PRELIMINARY PHASING PLAN

# STABLEWOOD FARMS
## PRELIMINARY OVERALL DEVELOPMENT PLAN
No.

Re: Stablewood Farms POADP # 675

Re: Stablewood Farms POADP # ?

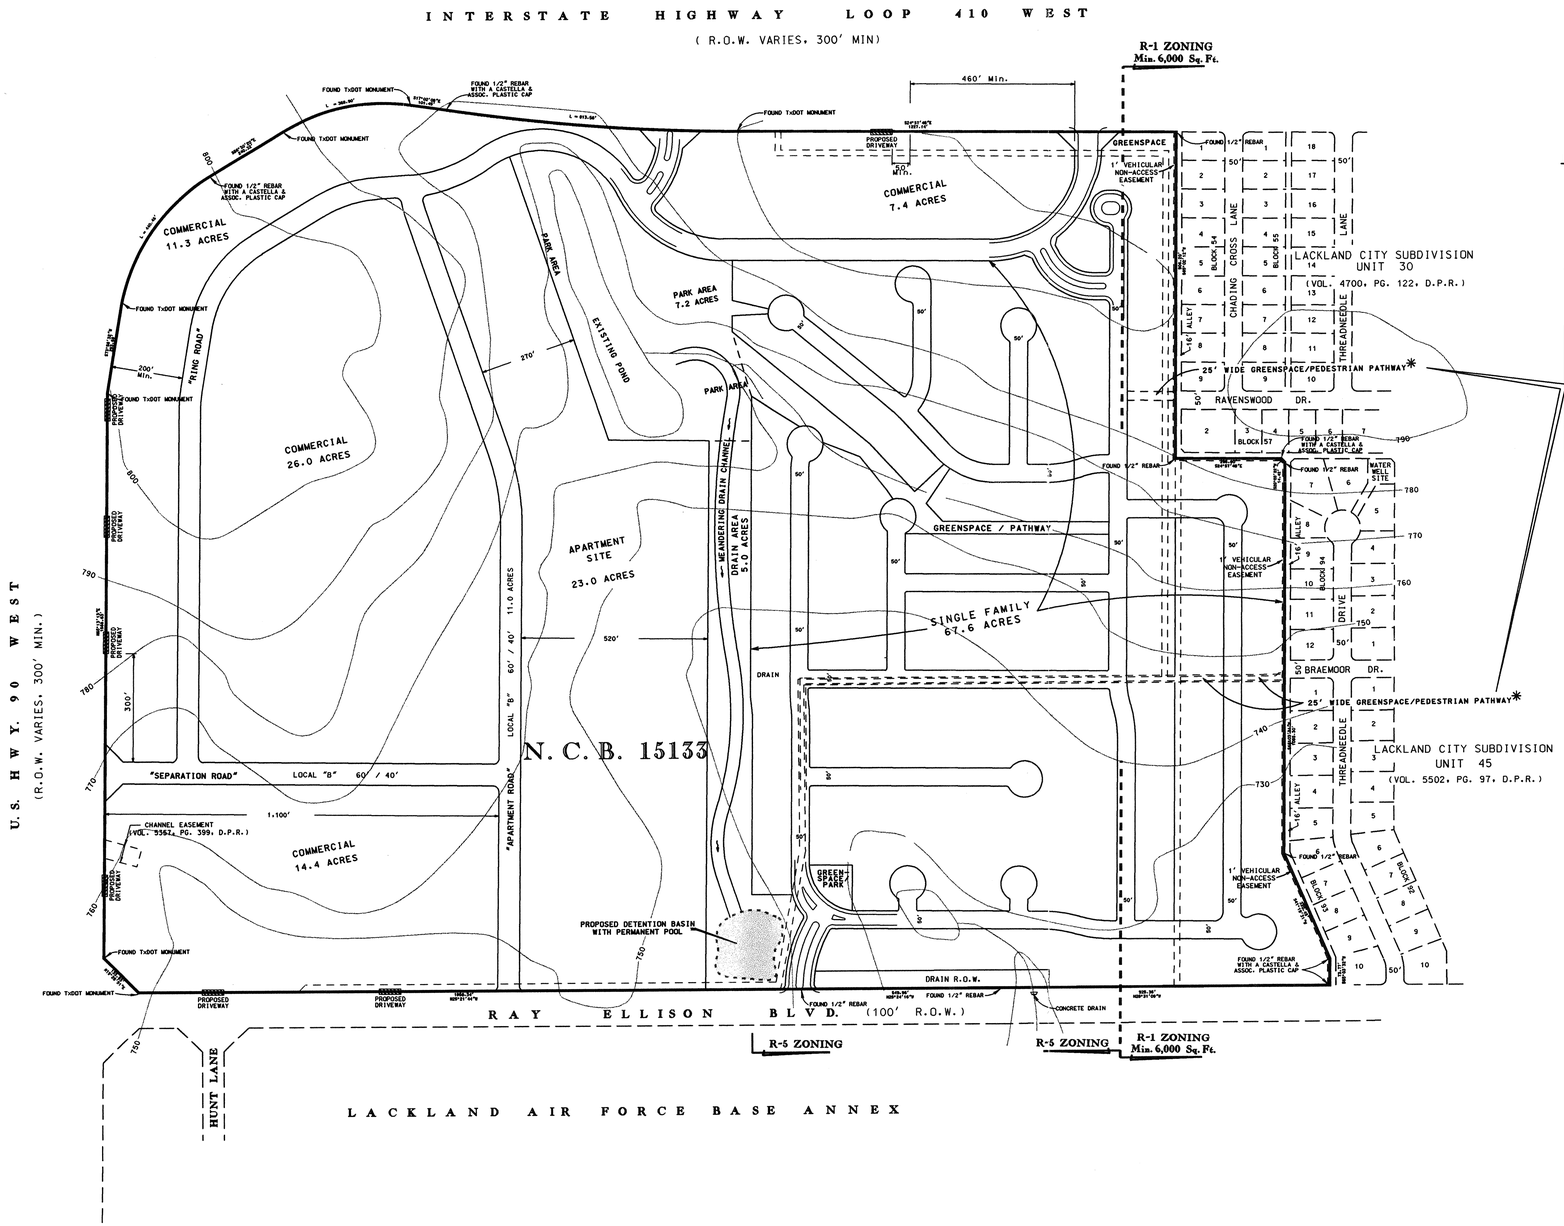
The City Staff Development Review Committee has reviewed Stablewood Frams Subdivision Preliminary Overall Area Development Plan # 675. Please find enclosed a signed copy for your files. Although your plan was accepted, please note the following:

- In consideration of public safety and convenience, excessive grades by reason of topography should be avoided in street layouts and arrangements.
- Access and R.O.W. issues along State facilities will need to be resolved with the Texas Department of Transportation (TXDOT). For information about these requirements you can contact TXDOT at 615-5814.
- This development will need to comply with tree preservation ordinance #85262. For information about these requirements you can contact Building Inspections at 207-7102.
- It will be expected that you will plat all of the property depicted in your POADP, to include: floodpains, drainage areas and open space.
- I would encourage you to work closely with the school district, so that they can plan accordingly.

1.) **Sec. 35-2075 Information Required**
(f) Contour lines at intervals no greater than ten (10) feet, Were shown but were **not labeled**.

(h) Existing adjacent or perimeter streets (including right-of way widths), intersection, and developments. **Were not properly labeled**.

2.) Connectivity to existing roads should be done when ever possible( Ravenswood Dr., Braemoor Dr.)

3.) Need Tx-dot Letter.

* PEDESTRIAN PATHWAY AND BICYCLE ACCESS. (NO STREET EXTENSION DUE TO MANDATED NON-ACCESS EASEMENT BETWEEN THIS SUBDIVISION AND ADJOINING LACKLAND CITY SUBDIVISION.

In regard to your May 15, 2000 letter to Robert Liesman of Macina, Bose, Copeland Engineers, Inc., please note we have worked extensively with the neighbors surrounding the above-referenced development at the direction of Councilman Raul Prado. At the request of the adjoining neighborhood association, a one-foot (1') vehicular non-access easement has been established along the southern border of our property as noted on the attached diagram to prevent any vehicular connectivity between the existing subdivision and our proposed project. However, we are planning to construct walking trails at Ravenswood Drive and Braemoor Drive to encourage pedestrian traffic between the existing development and our proposed project.

# STABLEWOOD FARMS
## PRELIMINARY OVERALL DEVELOPMENT PLAN
No.

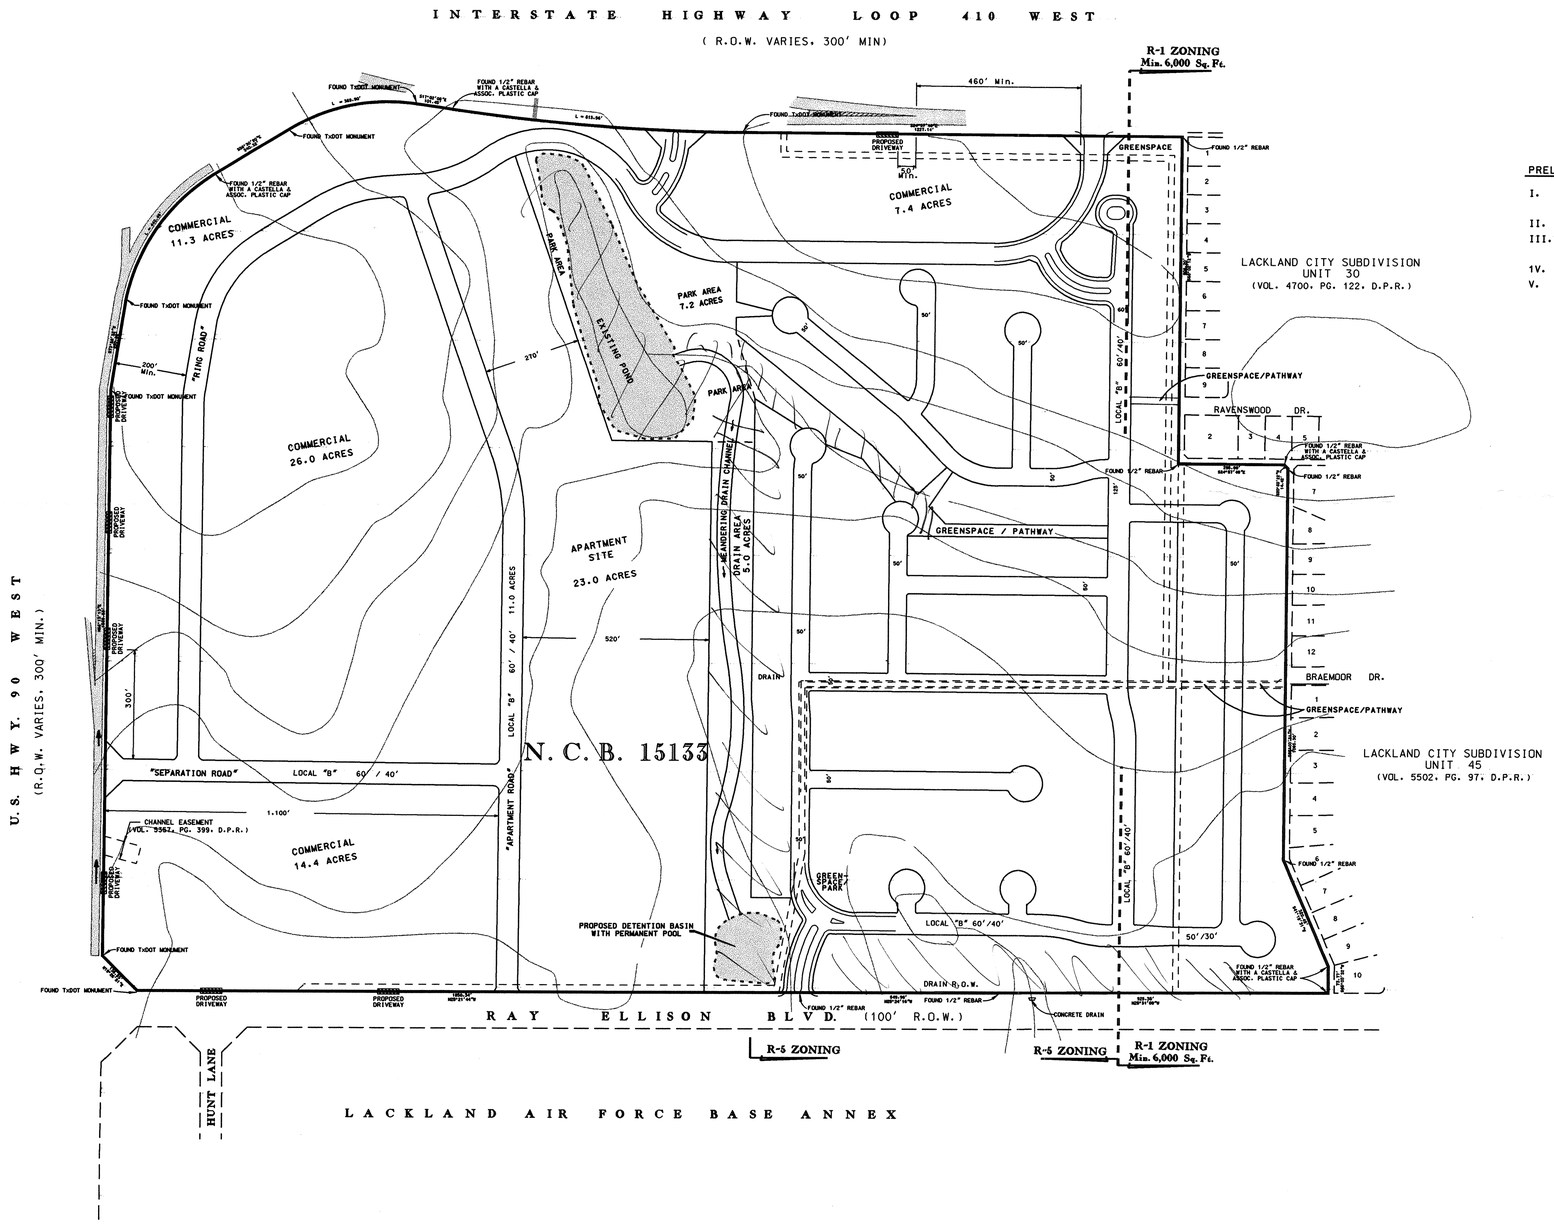
***P.O.A.D.P. REVIEW***
Stablewood Farms
Located on IH 410 @ US 90 West

| P.O.A.D.P. Reviewed for: | Comments |
|---|---|
| **Noise Mitigation** | For residential development directly adjacent to State ROW, the developer shall be responsible for adequate set-back and/or sound abatement. |
| **R.O.W. Requirements** | Future expansion of IH 410 and US 90 (which includes a direct connection interchange, will require an overall right of way width of 400'-500'. It is recommended that all development be setback a minimum distance of 50' (100' desirable) and this area be reserved for future highway widening. All applicable building setback distances would be measured from this reservation. |
| **Access Limits/Restrictions** | Locations of access points will be as directed by "Regulations For Access Driveways to State Highways". The number of the access points shown (driveways or proposed roads), which include five along US 90 and three along IH 410 appear acceptable, and will be considered the maximum allowable. Access points in the vicinity of exit ramps, shall be a minimum of 460' downstream from the ramp gore and a minimum of 50' upstream. Access points in the vicinity of entrance ramps, shall be a minimum of 100' downstream for the gore point and a minimum of 50' upstream. |

**Comments:** Ray Ellison Blvd is on the MTP requiring a min. 86' ROW.
U.S Hwy 90 west and Loop 410 is on the MTP and TxDOT system requiring min. 110' ROW and Txdot release

*This development shall be closely coordinated with the City of San Antonio and TxDOT during the design of the commercial parcels in order to limit the amount of driveways on IH 410 and US 90. The Engineering and Traffic Division recommends extending the two stub-out streets south of this development, Ravenswood and Braemoor, in order to provide adequate connectivity.*
